Engineering Note

14875-TUL-XX-XX-EN-S-90001

Re: DM/25/1679 64 Folders Lane, Burgess Hill, West Sussex / Surface Water Pumped Solution

Appendix A - 14875-TUL-XX-XX-DR-C-50001_M_Engineering Layout

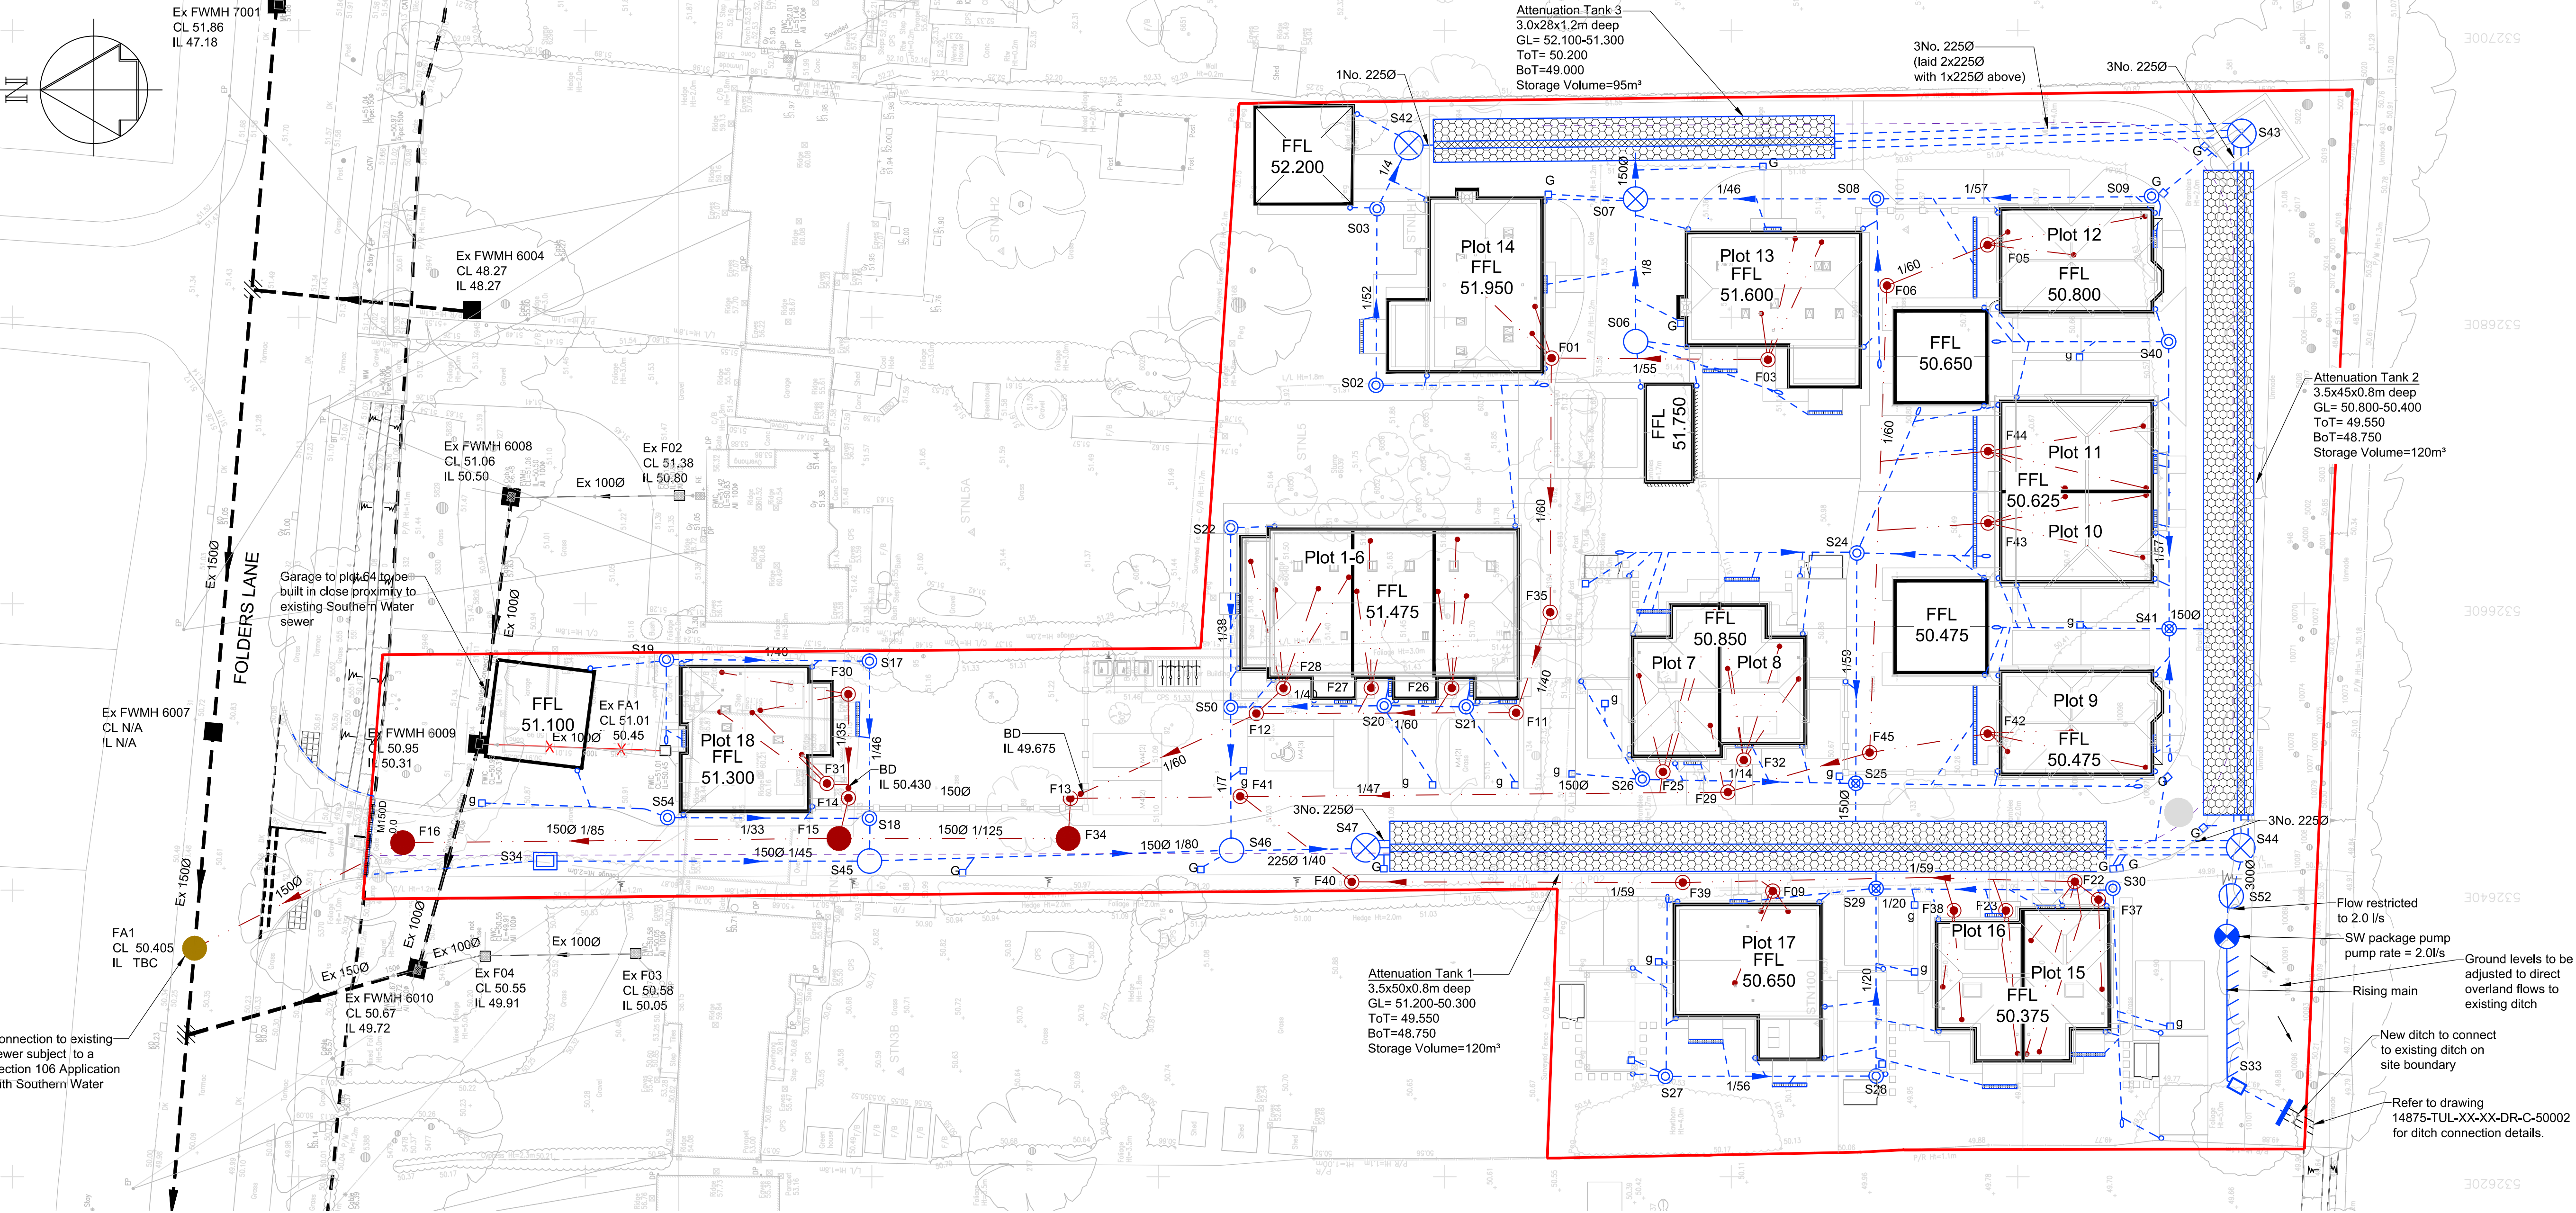
1. Detailed justification required why the application cannot be drained via gravity and a pump is required.

2. Full impact assessment of failure of a pumped system and emergency procedures to store 24 hours of water is required.

The original planning approved drainage details indicated that the surface water from the new development would discharge into the ditch directly adjacent to the site boundary. However, when surveys were undertaken it was found that the ditch was not deep enough to allow for a gravity connection.

Alternative outfall locations were considered however the new drainage system had already been installed at this point however there were limited options, all of which required pumping or crossing third party land. As the crossing of third party land could not be agreed, the only viable option was to provide a pump station on site to lift the surface water into the onsite ditch at the higher level, and thereby avoid the need to cross third party land.

The installed drainage system will remain as previously agreed, with a maximum restricted flow rate of 2.0 l/s and attenuation provided to accommodate a 100+CC event. The new pump chamber is located downstream of the flow control device, so there would be no impact on the installed surface water attenuation system, and the pump rate has been set at 2.0 l/s to match the maximum outflow from the hydrobrake.

The onsite outfall ditch has been extended slightly to accommodate the new drainage arrangement however the final outfall location remains as existing.

The pump station has been fitted with a duty and standby pump set. It will be managed for the lifetime of the development by a management company who will be responsible for the maintenance of the pump. Telemetry systems will be provided which will have a direct connection to the maintenance company.

Surface water attenuation has been provided on site to accommodate a 1 in 100+45% climate change event, which equates to a stored volume of 350m³. Whilst Building Regulations required 24-hour emergency storage for foul pump stations, we are not aware of any requirement to provide additional 24 hour emergency storage in the event of a failure of a surface water pump station.

However, in the event of both pumps failing during a storm event and the onsite attenuation system is overwhelmed, the pump chamber and the outfall ditch are located at the lowest part of the site and ground levels have been adjusted so that overland flows would naturally fall into the outfall ditch along the rear boundary, which follows the natural overland flood routes on the site.
